Reg.12-10/A.12-10-009
SDG&E CNF PTC Application

Subject: ED-SDG&E-05 SDG&E Partial Response

SDG&E March 4, 2014 Partial Response
A. 12-10-009 Cleveland National Forest Power Line Replacement Projects PTC
ED Data Request 5 Dated February 5, 2014
ED-SDGE-005: Alternatives 2-3

Subject: ED-SDG&E-05 SDG&E Partial Response - Alternative 1

Figure 1: Proposed Alternative 2 Alignment

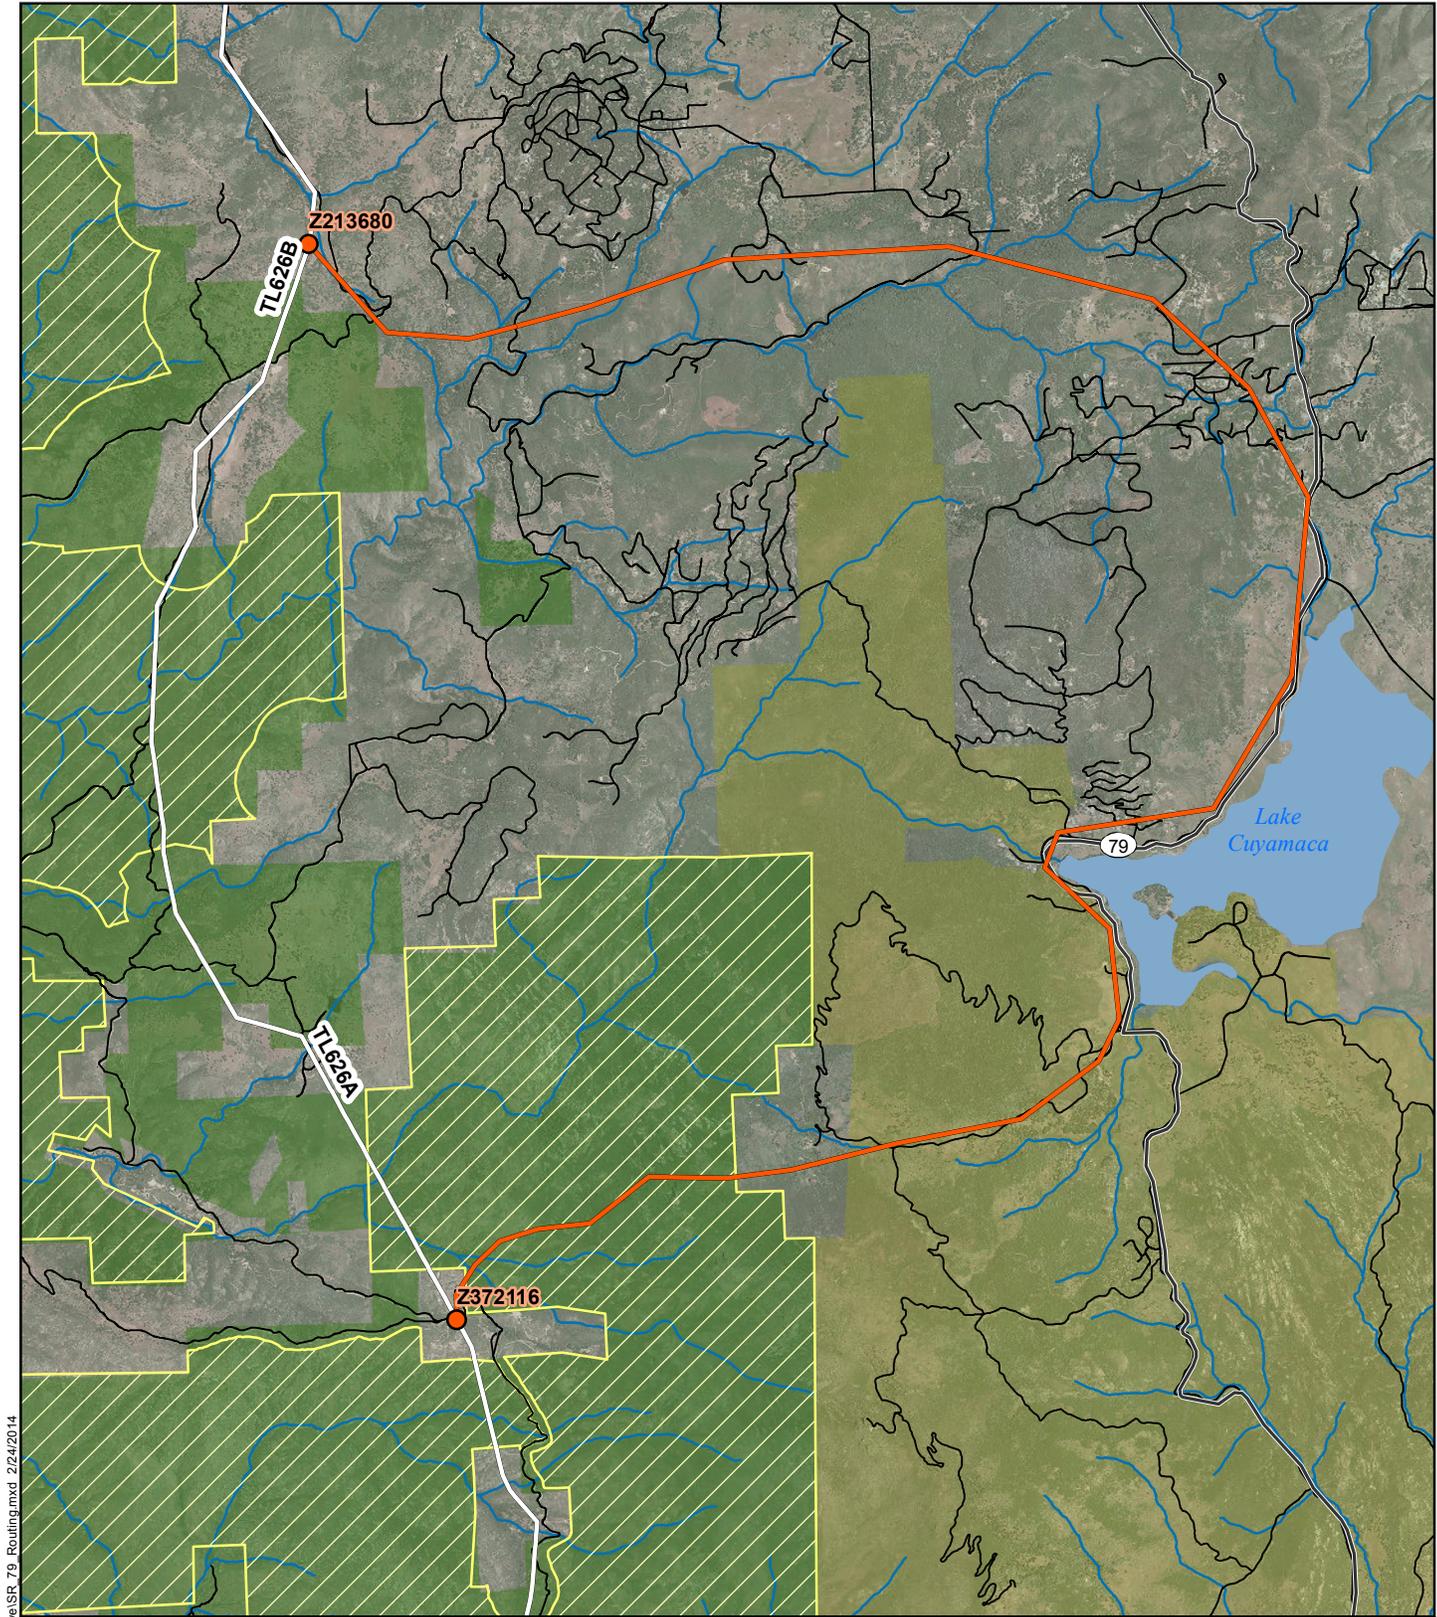
This alternative would remove a portion of TL 626 within the vicinity of the identified FS study corridor for TL 626 (around pole Z372116 to pole Z213680) and co-locate this segment of TL 626 with existing transmission facilities along SR79. Please describe the project components and construction activities and methods required to relocate TL 626 as described including any additional facilities required to meet the needs of existing energy users.

SDG&E does not currently have any transmission or power line facilities along State Route (SR-) 79; however, portions of one distribution circuit, C79, are located along this roadway for a portion of its length between Interstate (I-) 8 and SR-78. In order to collocate a segment of TL626 along SR-79, the existing C79 poles would need to be removed and replaced with steel poles similar in size and type as those described for the Proposed Projects in the Revised Plan of Development (POD).

As shown in Figure 1: Proposed Alternative 2 Alignment, the existing alignment for TL626 is located in the vicinity of Boulder Creek Road to the west of Cuyamaca Peak, Cuyamaca State Park, and the Cleveland National Forest's (CNF's) Sill Hill Inventoried Roadless Area (IRA); SR-79, however, is located to the east of these areas approximately 3.8 miles east of the existing TL626 alignment. The southern boundary of Cuyamaca State Park extends south of the southernmost pole identified for this alternative, Z372116, by approximately 1.8 miles. Similarly, the northern boundary of Cuyamaca State Park is located approximately 0.9 mile south of the northernmost pole identified for this alternative, Z213680. In order to realign the requested segment from its existing alignment to a location along SR-79, SDG&E would need to construct approximately 4.7 miles of new steel poles within the Sill Hill IRA, Cuyamaca State Park, and private lands to reach SR-79 to the east. Once along SR-79, SDG&E would construct approximately 4.1 miles of new steel poles on private lands along SR-79. In order to reconnect the new alignment with the existing alignment at pole Z213680, SDG&E would then construct approximately 5.4 miles of new steel poles on private lands. Because detailed engineering on this alternative has not been completed, SDG&E estimated the approximate number of poles that would be required for this alternative based on the average number of poles per mile along the existing TL626 alignment; actual pole numbers may vary significantly according to local topographical, environmental, and engineering requirements. Table 1: Approximate Pole Requirements for Alternative 2 displays the estimated number of poles that would be required to be constructed in the Sill Hill IRA, Cuyamaca State Park, and on private lands in order to

relocate this segment of TL626 to along SR-79. In addition, approximately three existing poles north of pole Z372116 would be required to be reconstructed to serve existing customers along the existing alignment, and approximately 23 existing poles south of pole Z213680 would be required to be reconstructed to serve existing customers along the existing alignment.

With the inclusion of this alternative alignment, TL626 would total more than 30 miles in length between Descanso and Santa Ysabel substations. The installation and operation of a 69 kV power line of this length is not optimal due to voltage drop and other operational concerns.

In addition to the new alignment, SDG&E estimates that approximately 6.5 miles of new access roads on private lands would need to be established for construction, operation, and maintenance of the new alignment segment. All poles located within the Sill Hill IRA would be constructed and maintained using helicopter access. Construction activities and methods used for this alternative would be the same as those described in the Revised POD.

Figure 1: Underground Alternative - Option 1

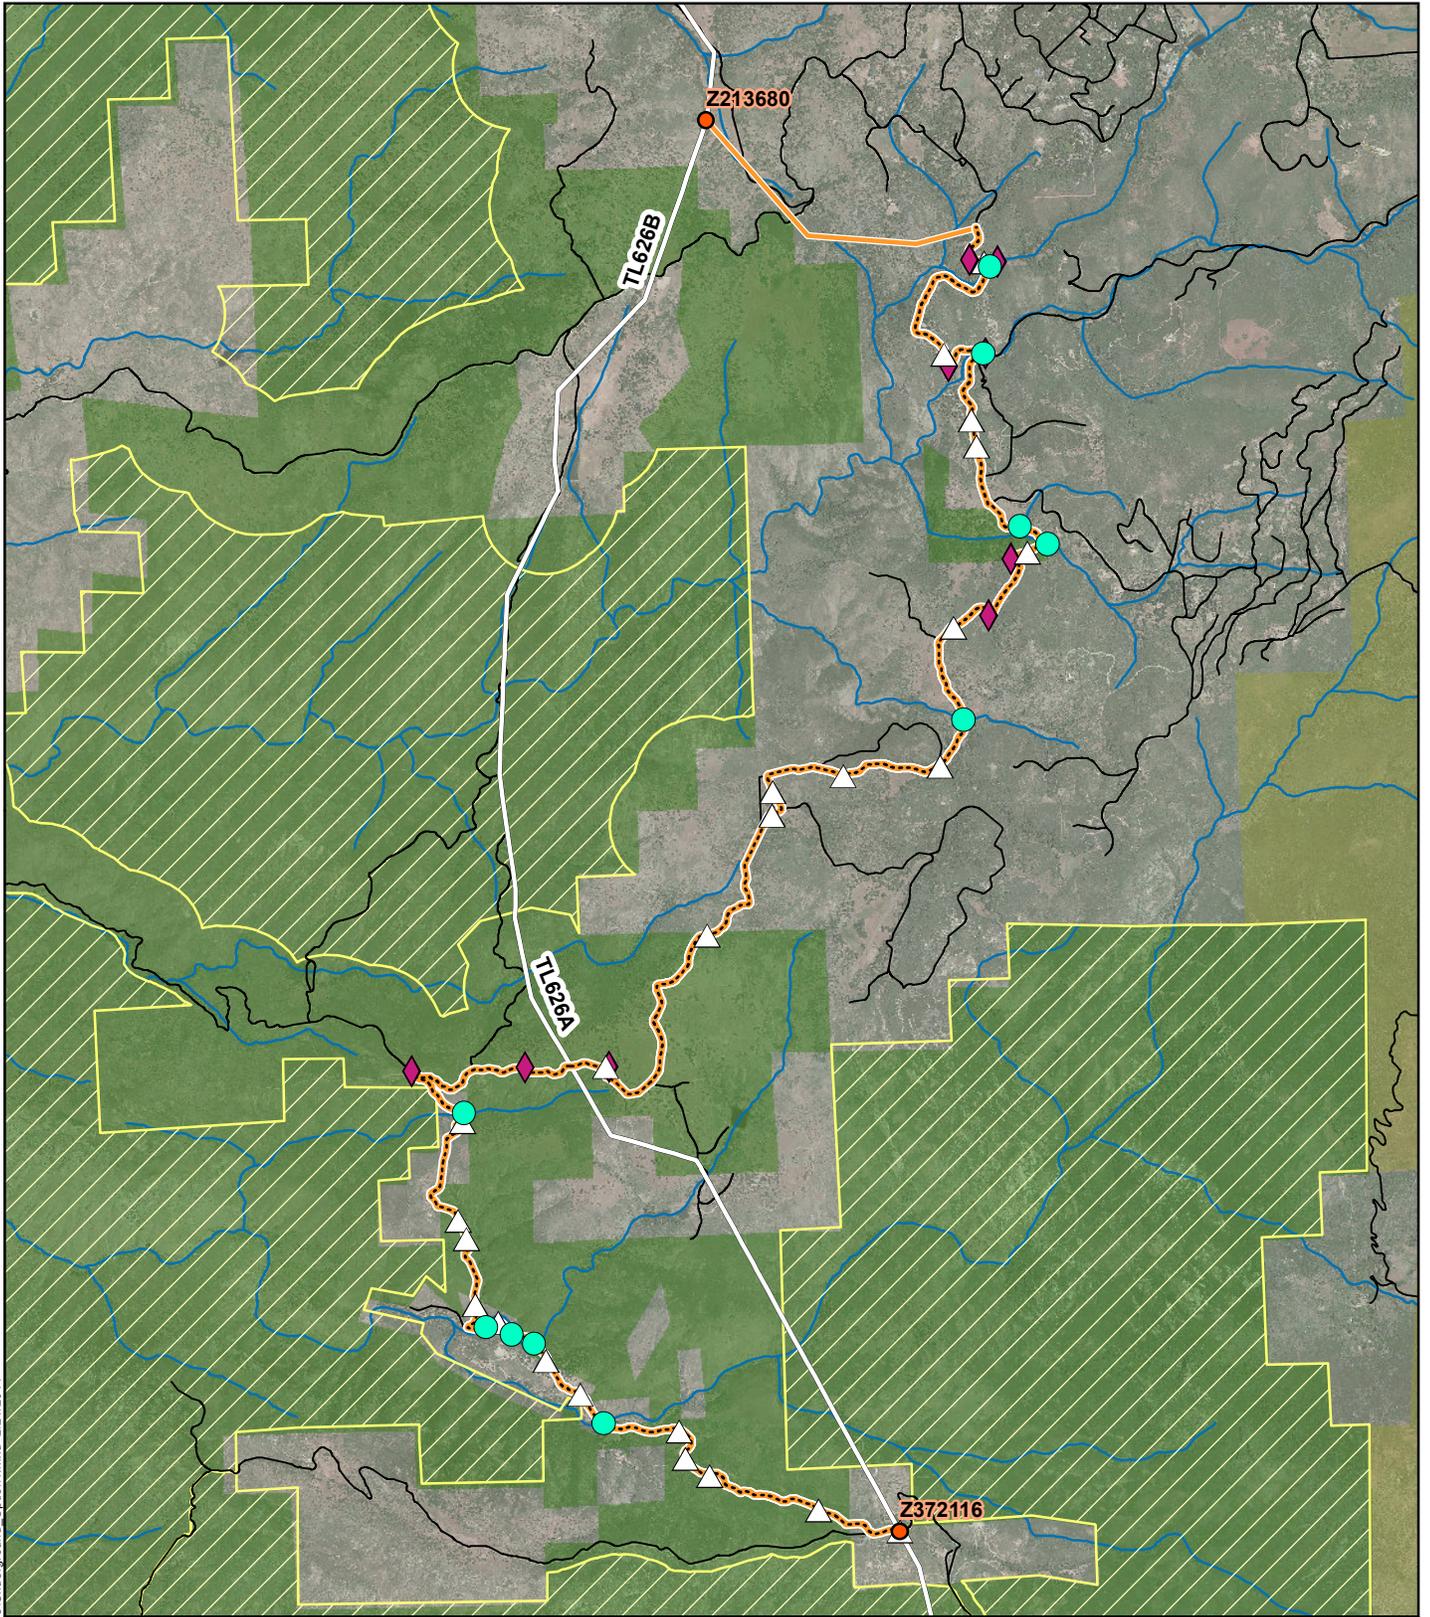
This alternative would partially underground TL 626 within Boulder Creek Road within the vicinity of the identified FS study corridor for TL 626. Two options have been identified. Option 1 starts at the southernmost pole location (Z372116) and ties back into the overhead portion of TL 626 around pole (Z213680). Under option 1, a portion of C79 would need to be undergrounded. Option 2 starts at pole (Z372142) north of C79 and would tie back into the overhead portion of TL 626 around pole (Z213680). Please describe the project components and construction activities and methods required to underground TL 626 as described including the temporary and permanent footprint required, number of vaults and any other facilities required.

As shown in Figure 1: Underground Alternative – Option 1, this option would include undergrounding TL626 from pole Z372116 approximately 11.4 miles along Boulder Creek Road, at which point the line would return to an aboveground configuration. An additional approximately 1 mile of overhead alignment would be required across private lands to reconnect the underground alignment with the existing overhead alignment at pole Z213680. Along the approximately 11.4-mile-long segment of Boulder Creek Road, approximately 12 turns have an insufficient radius within the existing road bed to permit construction of underground duct packages or stringing of conductors due to minimum design requirements of the materials proposed to be used. Approximately 25 locations along this segment of Boulder Creek Road exceed 12 percent slope, which is the maximum slope feasible for underground conductor installation. Additionally, this segment of Boulder Creek Road crosses approximately 10 hydrological features through which open trenching would not be feasible. For the purposes of this analysis, these 47 locations would require jack-and-bore or HDD construction techniques to be used, resulting in approximately 75,200 square feet (approximately 1.7 acres) of temporary impacts during construction. The remaining approximately 10.5 miles of Boulder Creek Road would be open trenched, resulting in approximately 138,600 square feet (approximately 3.2 acres) of temporary impacts during construction. Assuming jack-and-bore pits require excavation to only 20 feet in depth, Option 1 would result in approximately 90,000 cubic yards of temporary excavation. Assuming one splice vault is required for every 1000 feet of the duct package, approximately 60 splice vaults would be required for Option 1.

Stringing sites would generally be placed along the road in disturbed areas, and would be required every approximately 1 mile to conduct stringing activities. Staging of materials and equipment would also be required along Boulder Creek Road or in the vicinity of work areas; assuming three staging areas along Boulder Creek Road are used, and each are approximately 2 acres in size, an additional approximately 6 acres of temporary impacts would occur during construction.

Depending on local site conditions, and additional approximately 15 steel poles and associated conductors would be required to reconnect the underground alignment with the existing alignment at pole Z213680, resulting in approximately 0.4 acre of additional temporary impacts and approximately 0.01 acre of permanent impacts.
